TECHNICAL BULLETIN

RIDGE RACER 2 ACCELERATOR/BRAKE ASSY

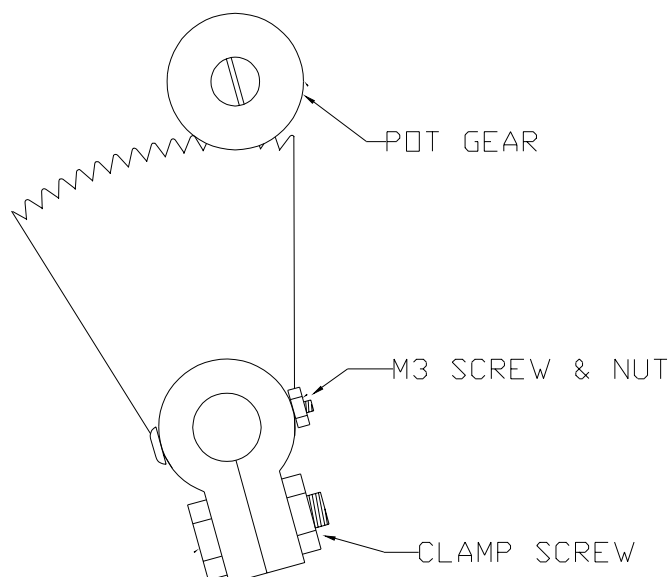
Problem:- Not accelerating properly and/or brake remaining partly on.

Cause:- Quadrant Gear moving on the shaft.

Remedy:- Drill a 3mm hole through the quadrant gear and shaft and fit an M3x15 screw and nut.

1. Remove four hex head bolts (M6x20) and withdraw the pedal assembly forward from the machine.
2. Disconnect the connector.
3. Loosen the quadrant gear clamp screw and remove the quadrant gear.
4. Turn the potentiometer shaft almost fully clockwise and refit the quadrant gear (see diagram below for correct position) ensuring that the clamp screw is fully tightened.
5. Drill a 3mm diameter hole through both the quadrant gear and shaft and fit an M3x15 screw and nut as shown.
6. Connect the connector and refit the pedal assembly to the machine.
7. **Re-initialize the game (see operators manual) before the game is played.**
